ADDENDUM NO. 2

SUBJECT: Addendum No. 2 – Downtown Street and Sidewalk Improvements
Cochran Project No. SW20-285

DOWNTOWN STREET & SIDEWALK IMPROVEMENTS
CITY OF OZARK

CONCRETE STAIRS WITH HANDRAILS
NO SCALE

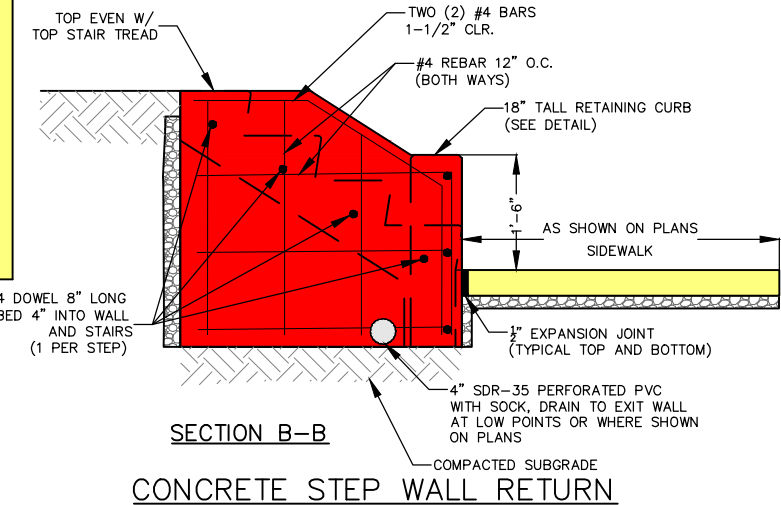
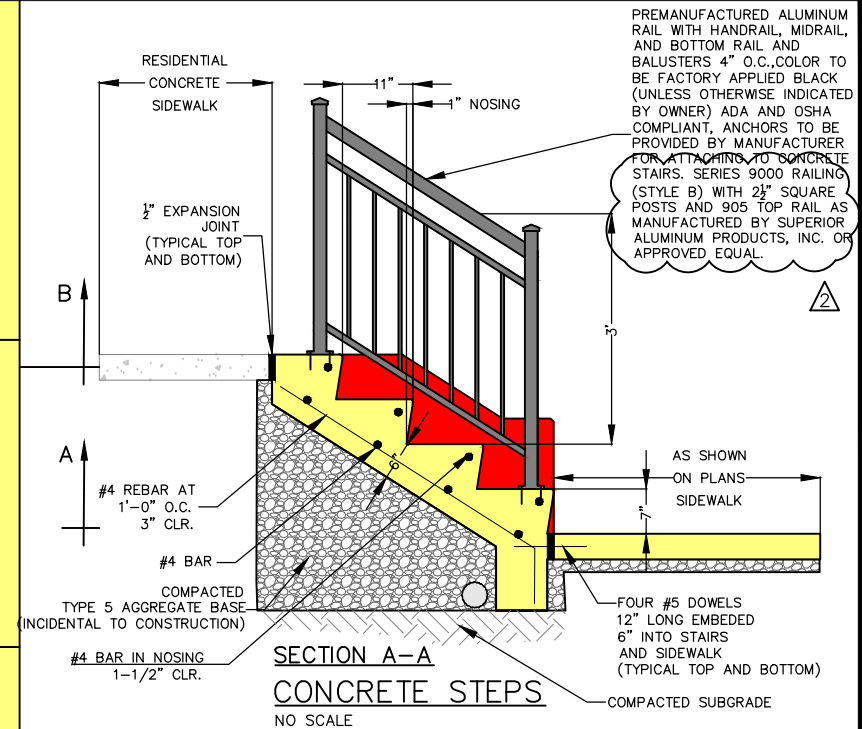
2. Contractor Question: Does the owner want aluminum or steel handrail for the "Concrete Stairs with Handrails"? Plans show aluminum but the specifications (3200 Misc. Metals) are designed around steel. If aluminum is the desired option, is there a specific "premanufactured" brand of aluminum handrail the owner desires or is this just to clarify that no "field welding" will be allowed. Can the owner provide a more detailed handrail design? Baluster size/weight, rail size/weight, post size/weight, square or round tubing?
Clarification to specification 3200 Misc. Metals. Handrails listed in the specification do not apply to "Concrete Stairs with Handrails Detail" on Plan Sheet D-11 – Details. The Concrete Stairs with Handrails detail has been updated to provide the additional requested information. See attached Revised Plan Sheet D-11.

PREMANUFACTURED ALUMINUM RAIL WITH HANDRAIL, MIDRAIL, AND BOTTOM RAIL AND BALUSTERS 4" O.C. COLOR TO BE FACTORY APPLIED BLACK (UNLESS OTHERWISE INDICATED BY OWNER) ADA AND OSHA COMPLIANT, ANCHORS TO BE PROVIDED BY MANUFACTURER FOR ATTACHING TO CONCRETE STAIRS. SERIES 9000 RAILING (STYLE B) WITH 2 1/2" SQUARE POSTS AND 905 TOP RAIL AS MANUFACTURED BY SUPERIOR ALUMINUM PRODUCTS, INC. OR APPROVED EQUAL.
